**Proposed Temporary Private Vehicle Park for a Period of 3 Years and Filling of Land in “Village Type Development” Zone, Lot 741 (Part) in D.D. 111, Pat Heung, Yuen Long, N.T.**

## Responses to Comments for Drainage Services Department

**Subject:** Re: Planning Application No. A/YL-PH/1069 - Departmental  
Comments

Responses to Comments for Drainage Services Department  
Planning Application No. TPB/A/YL-PH/1069

LOCATION OF THE EXISTING MANHOLE

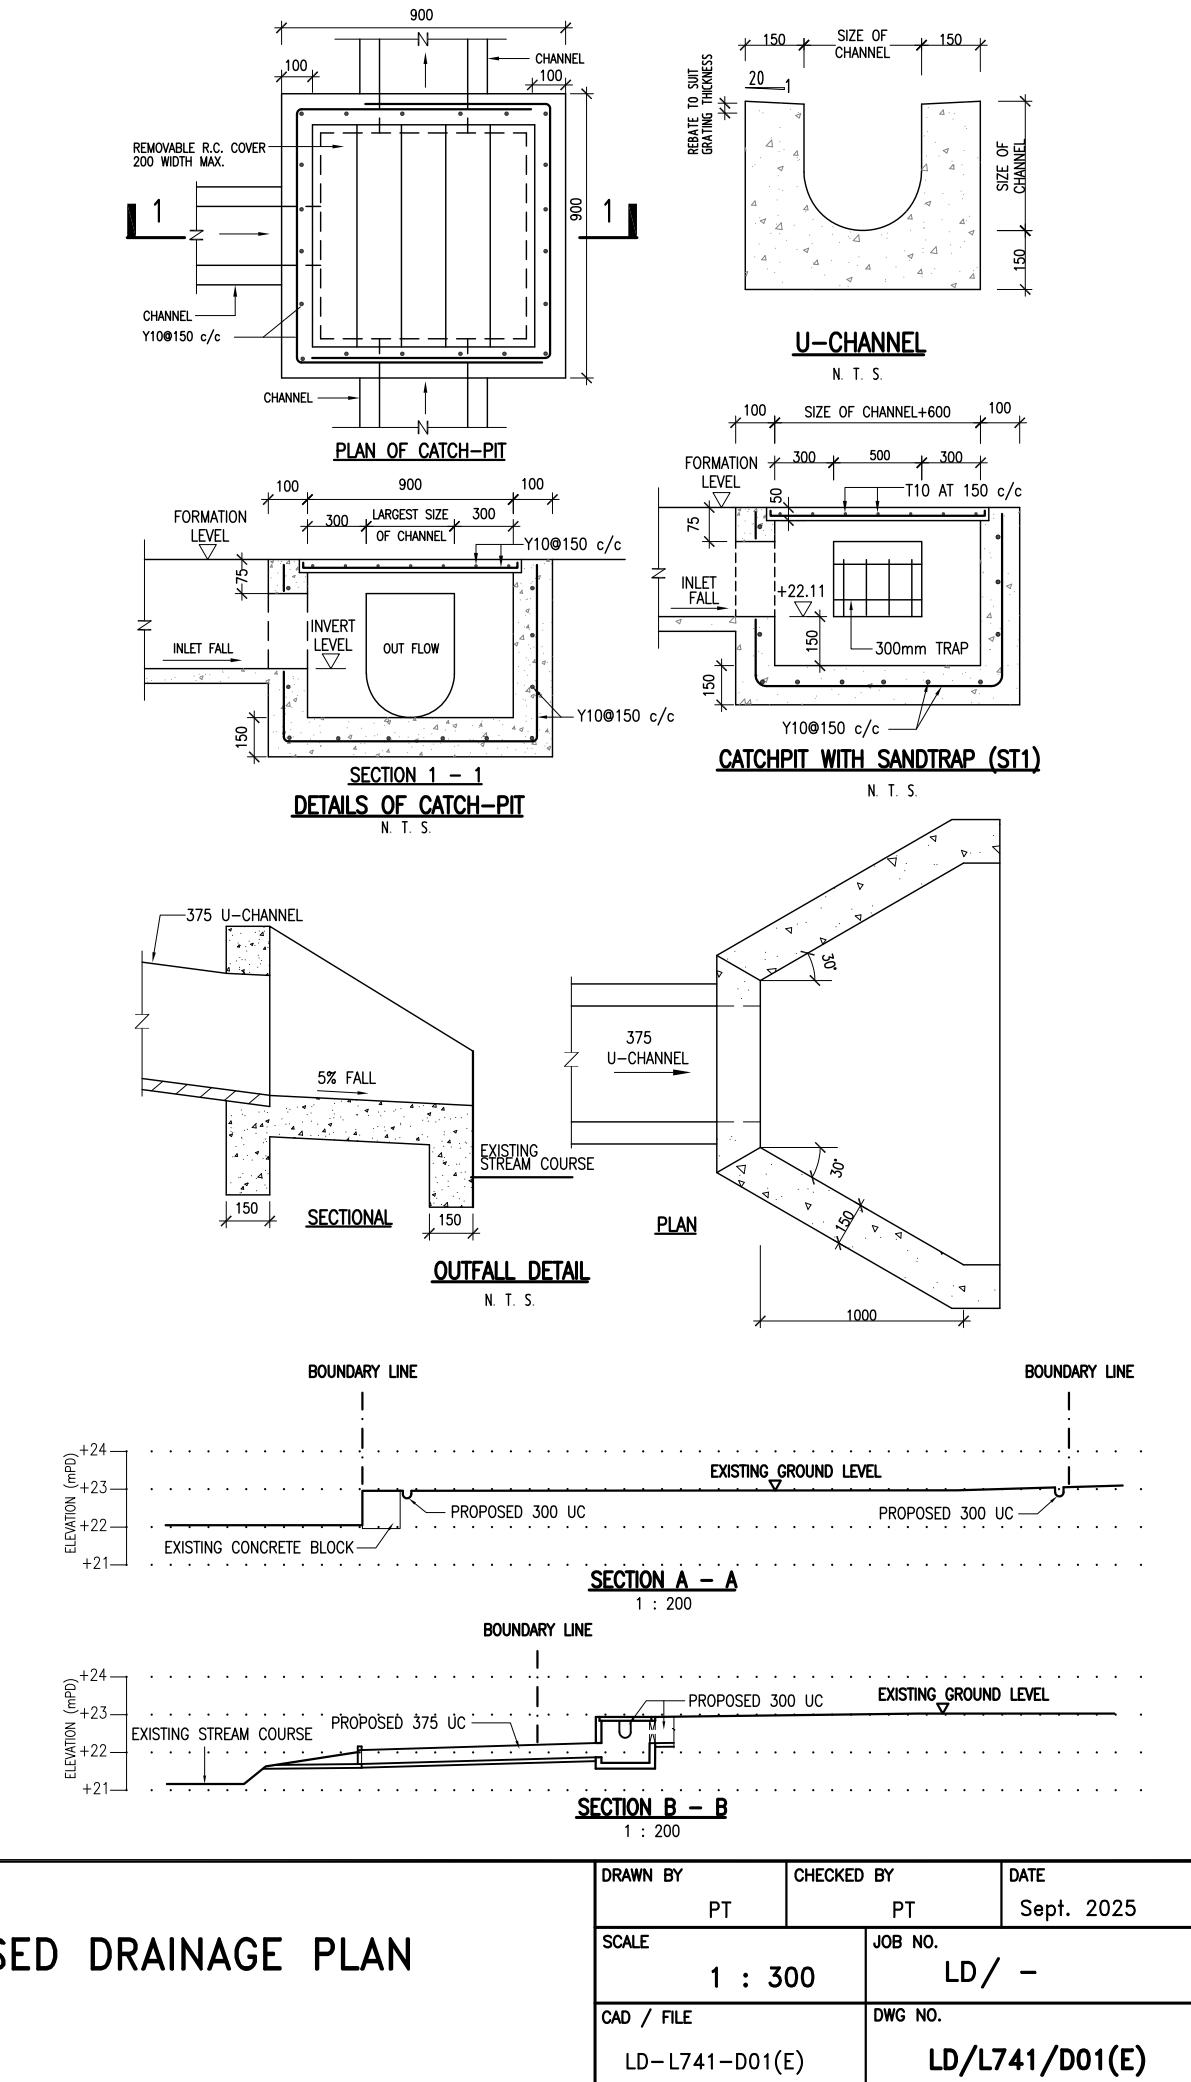
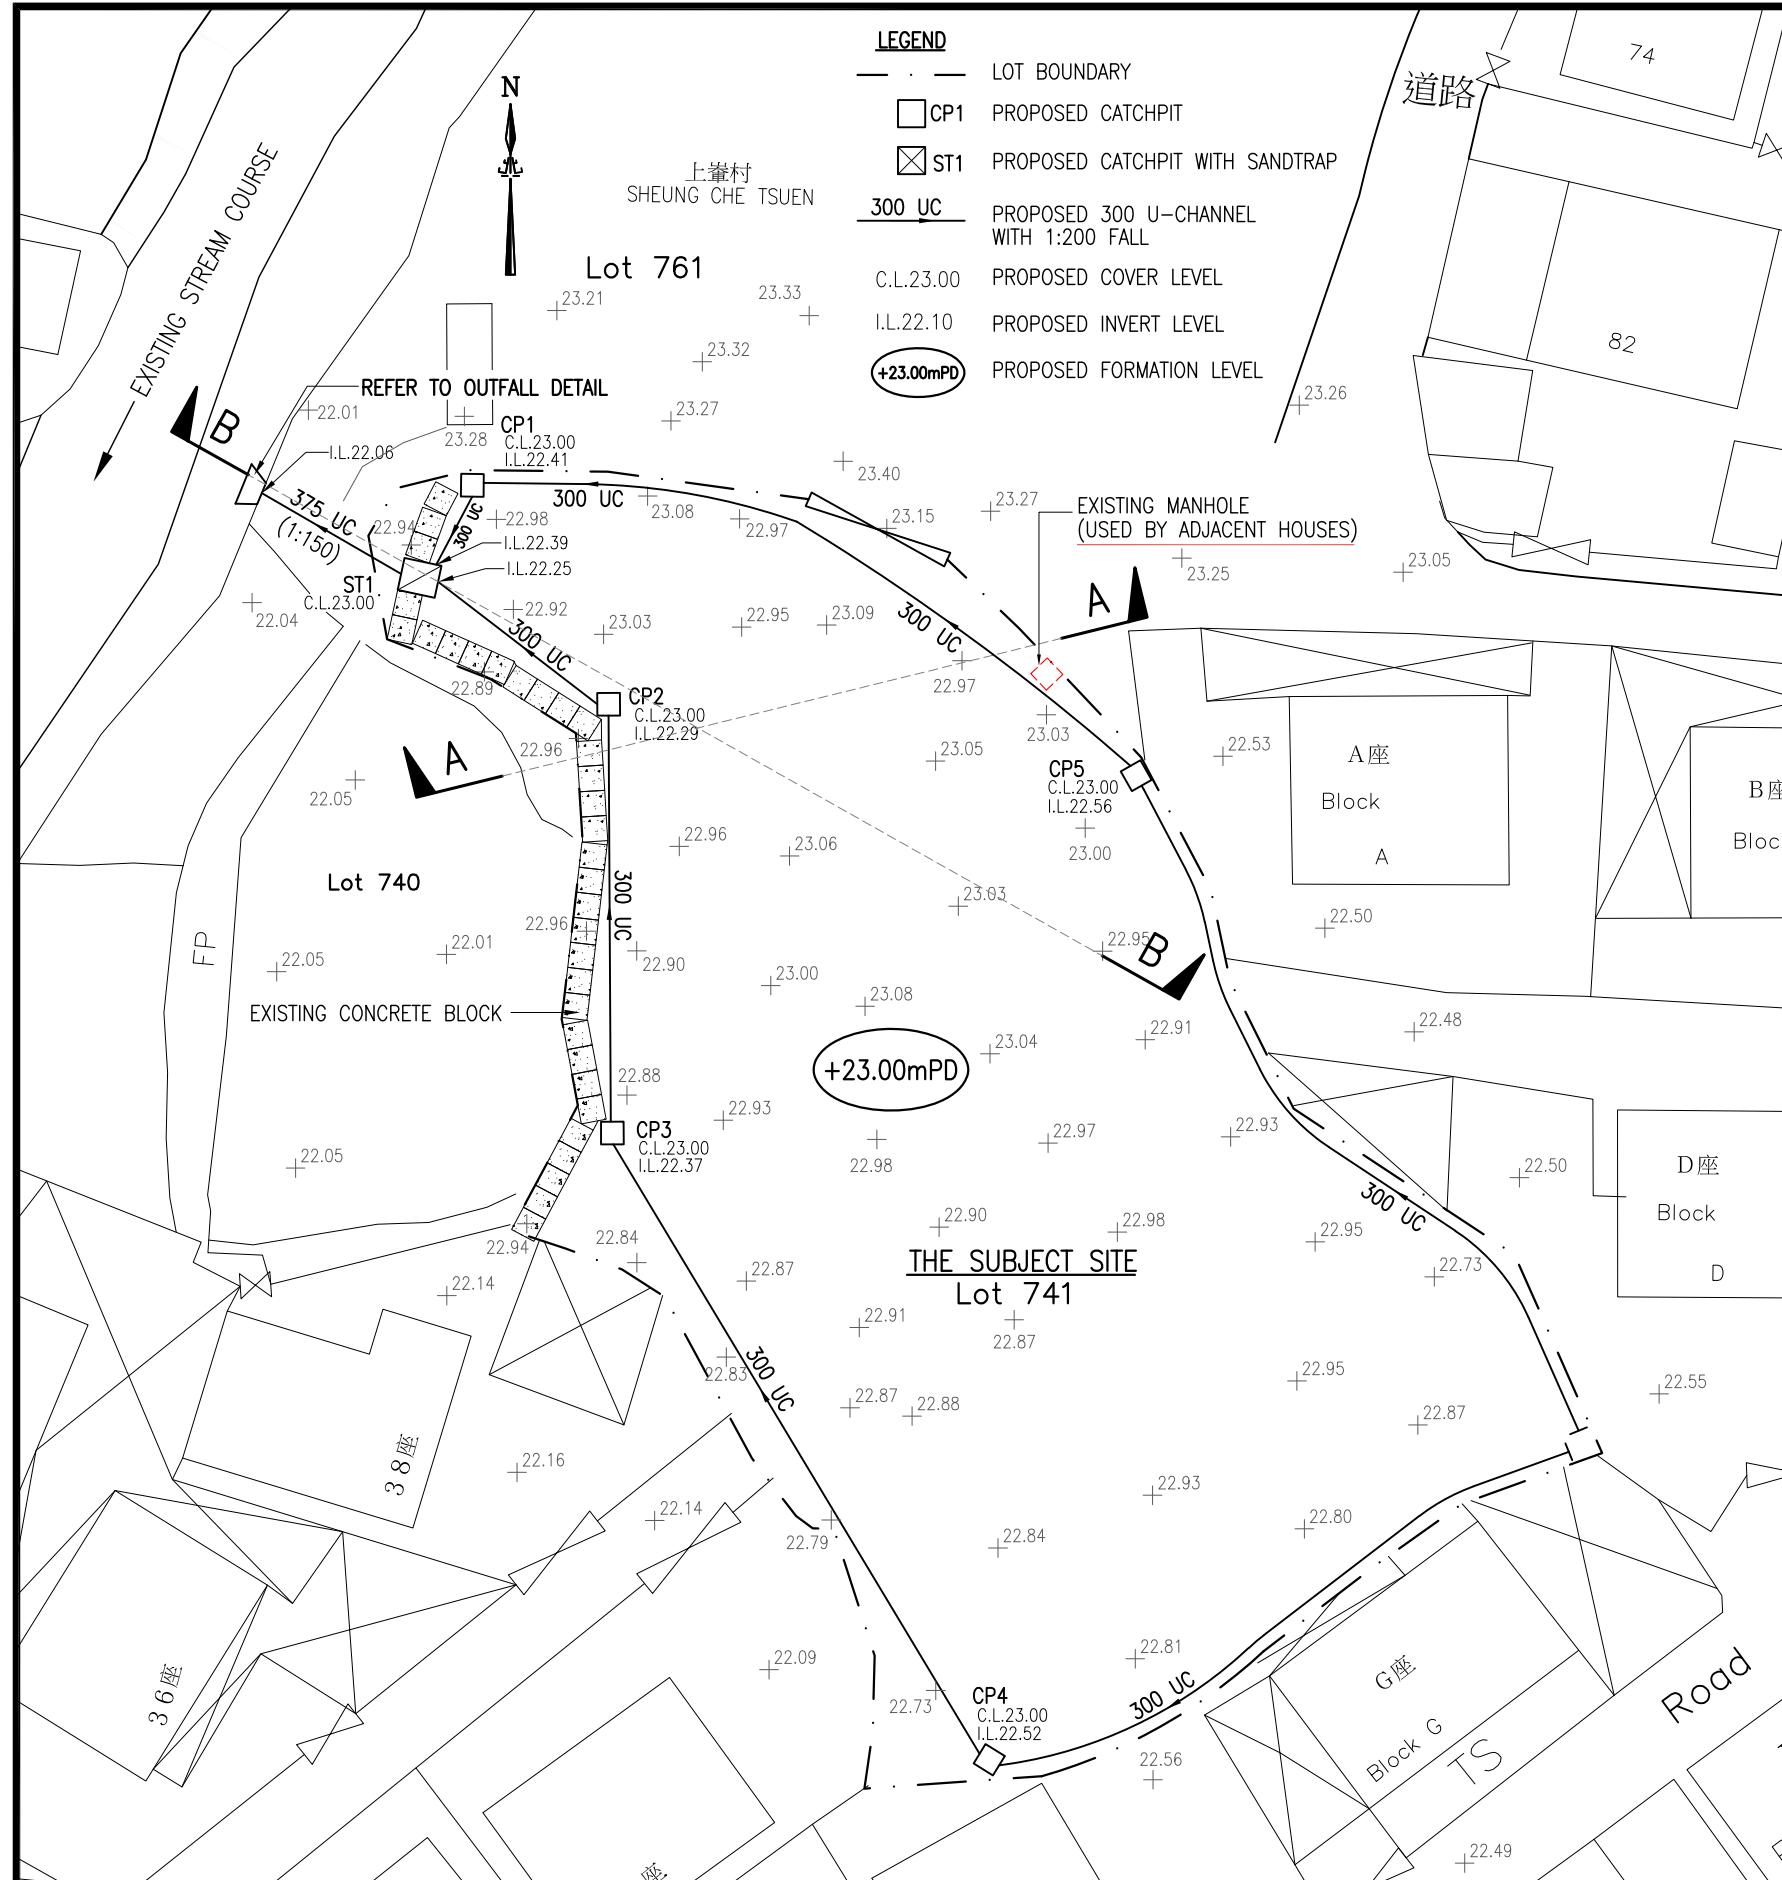
<p>1. The applicant is advised to response to his comments given on 5 June 2025.</p> <p>2. The applicant revised the I.L.s. at the channels start points near Lot no. 743 S.D in D.D. 111, proposed catchpit CP5 and catchpit CP1. However, the I.L.s. of the proposed catchpits CP4, CP3, CP2 and ST1 are not tally with the I.L. of the channel starting point i.e. +22.21mPD. please check and revise.</p> <p>3. He supposes the proposed drainage system will intercept the drains discharged from the adjacent area. Please provide connection details including all C.L., I.L. and B.L. for the drains, and all other drains affected by the proposed development, as shown in the attached photos for our consideration.</p> <p>4. Please note that the above comments are provided from drainage point of view. Since the site formation levels and any associated works proposed by the applicant may affect adjacent land and cause other impacts and/or other issues to public, please consider to require the applicant to submit technical assessment(s) in other aspect(s) and seek comment from relevant departments as necessary.</p>	<p>1. The existing Manhole was constructed beside the fence wall, please see appendix -1</p> <p>2. See attachment drawing</p> <p>3. The adjacent area was collected by existing manhole (see appendix-1)</p> <p>4. Adjacent land may not be affected during the existing pipes to be connected the adjacent area and carried water away</p>
